# Update on TDECQ CER evaluation

Addressing comments #247, #248, #249 and #250 against IEEE 802.3dj D2.2

Roberto Rodes, Coherent

Tx2

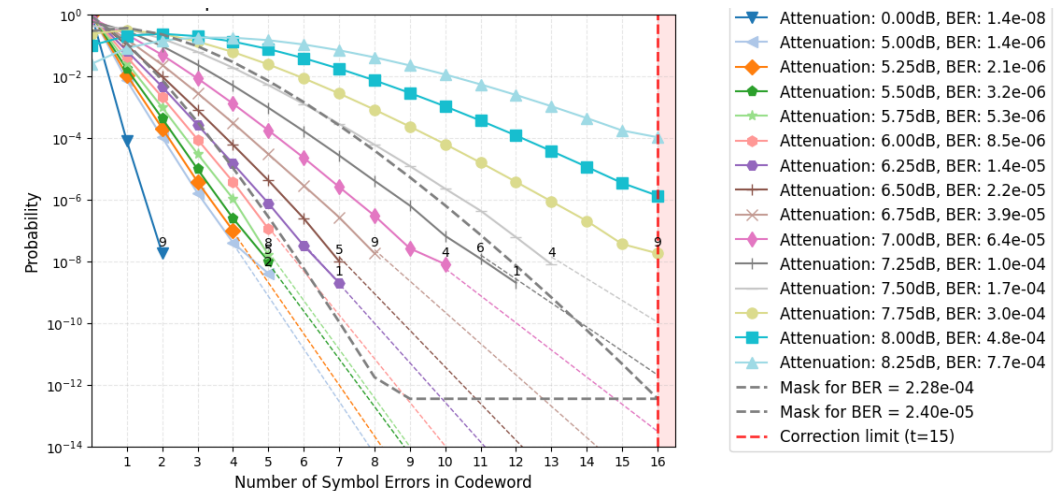
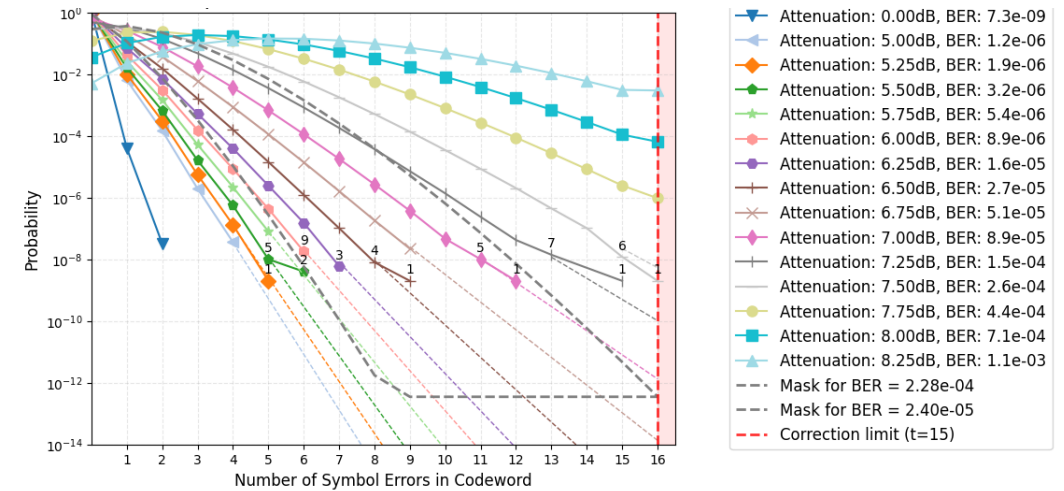
Results					
Measurement		Current	Minimum	Maximum	Count
CER TDECQ	F1	3.25 dB	3.07 dB	3.63 dB	5
TDECQ	F1	2.70 dB	2.70 dB	2.76 dB	5

Tx4

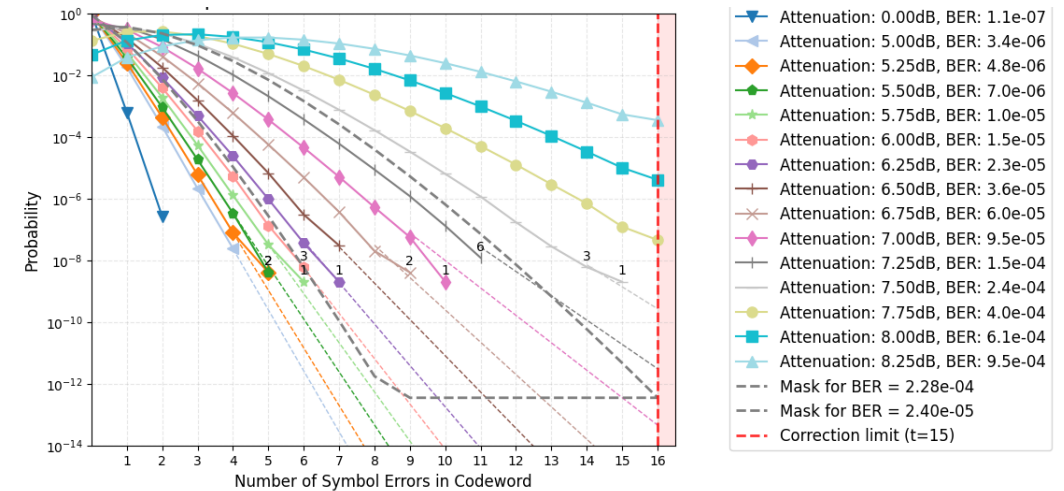
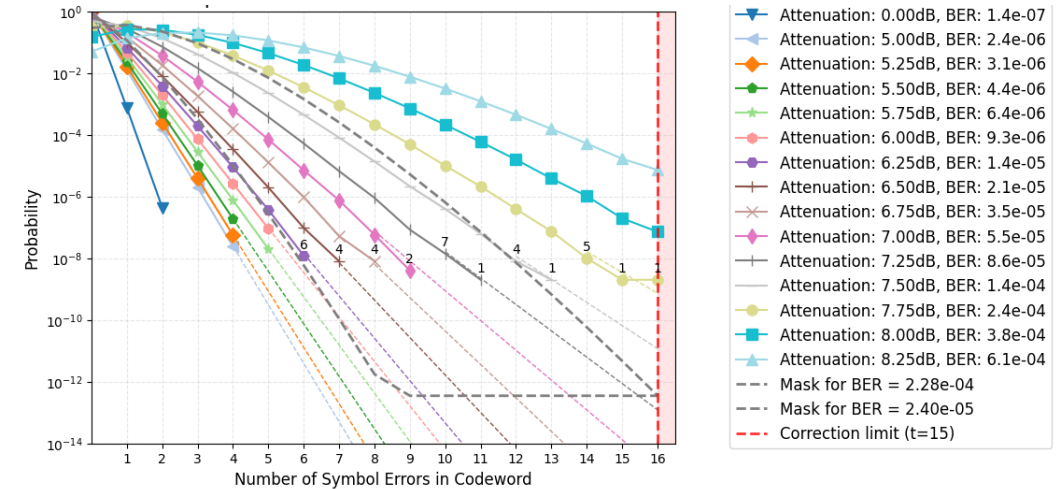
Results					
Measurement		Current	Minimum	Maximum	Count
CER TDECQ	F1	SER?	3.06 dB	3.44 dB	4
TDECQ	F1	2.66 dB	2.61 dB	2.66 dB	6

# Results Summary

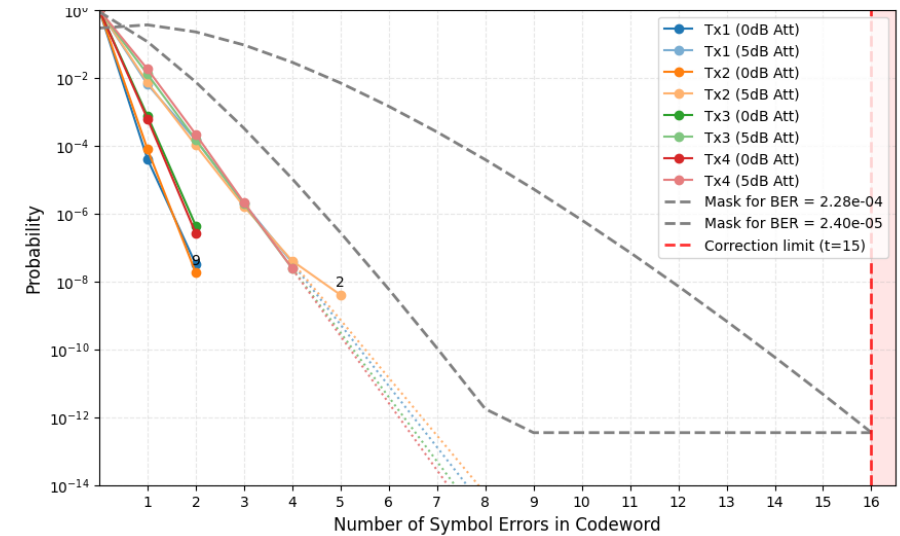
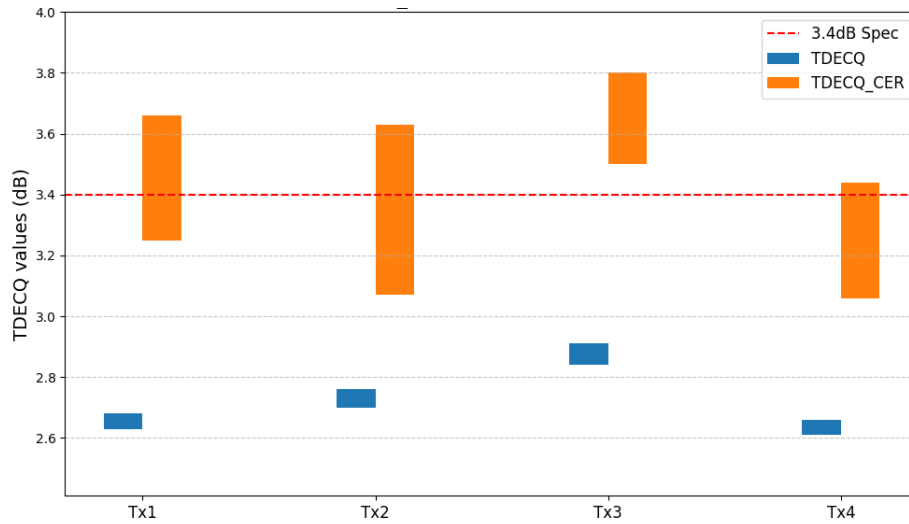
The TDECQ\_CER variation is approximately 10× higher than the TDECQ.

All transmitters show plenty of margin in the link. Even with a 5 dB loss (compared to the 3 dB maximum DR4 channel loss), all Txs maintain large margins in both OMA and codeword error ratio, easily covering any potential Rx-to-Rx variation.

However, TDECQ\_CER is generating false positives, disqualifying transmitters that perform without issue in the link.

- Remove the TDECQ\_CER specification, or
- Increase the limit to 4.4 dB, or
- ~~Make the specification informative rather than normative.~~
